Crystal River Unit 3
Docket No. 50-302
Operating License No. DPR-72

June 14, 2001
3F0601-03

Subject: Crystal River Unit 3 - License Amendment Request #262, Revision 1, and Response to NRC Request for Additional Information RE: License Amendment Request #262, Revision 0, "Alternative Source Term and Control Room Emergency Ventilation System" (TAC No. MB0241)

Figure 2

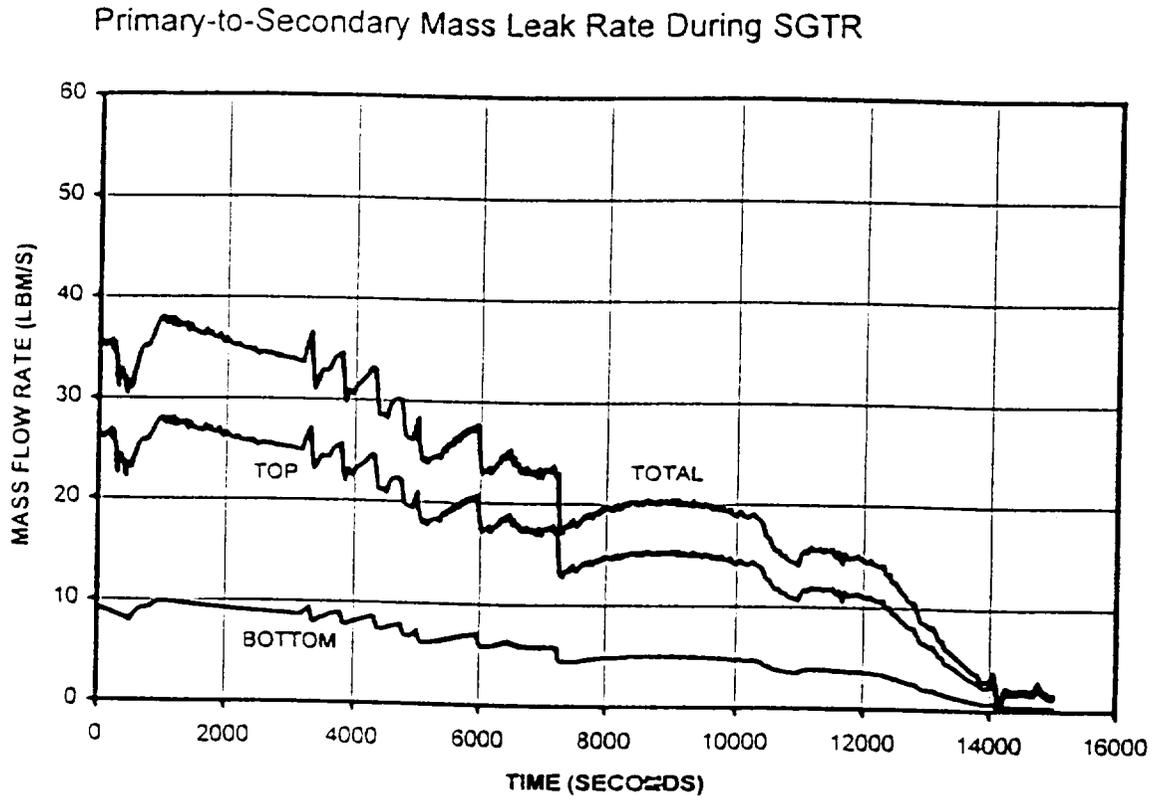
The primary to secondary mass flow rates for the SGTR are shown in Figure 2. Average rates for each of the 4 time periods are approximated as follows:

0-0.13 hrs – 33 lbm/sec (note – releases over this time period are to the condenser and are reduced by a factor of 100)
0.13 - 0.63 hrs – 36 lbm/sec – released directly to atmosphere with no decontamination factor (DF)
0.63-1.8 hrs – 30 lbm/sec – released directly to atmosphere with no DF
1.8 - 8 hrs – Although Figure 2 shows a primary to secondary mass flow for this time period, this flow is into the affected generator, which is isolated at 1.8 hours. Hence, activity in this flow will not be released. The activity being released during this period is only from the assumed 150 gallons/day primary to secondary leak in the unaffected generator, which is assumed to be released directly to atmosphere with no DF.
